GLASS DOOR HINGE REPLACEMENT

All Tumble Dryers with glass door.

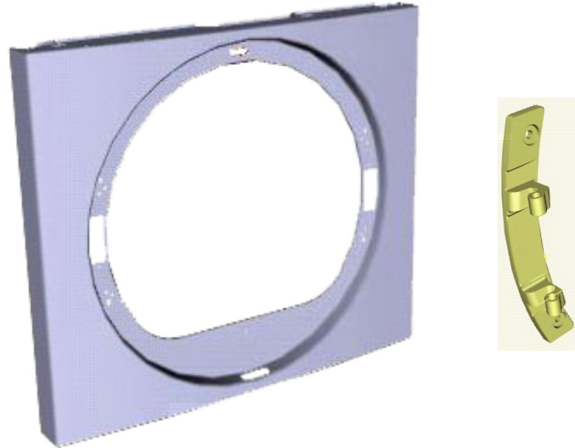
Due to problem with glass door tilting down door hinge 1366253217 is no longer available. It has been replaced by new door hinge and front panel set.

Attempt to fit new hinge in old front panel will cause deformation of panel.

Old door hinge must be replaced by set of new hinge and new front panel.

Old door hinge	Old front panel	New front panel and door hinge Kit
1366253209 1366253217	1367004007	4055344131
	1367004023	
	1367004049	
	1367004056	4055306585
	1367004080	
	1367004320	
	1367004411	
		4055306593
		4055280756
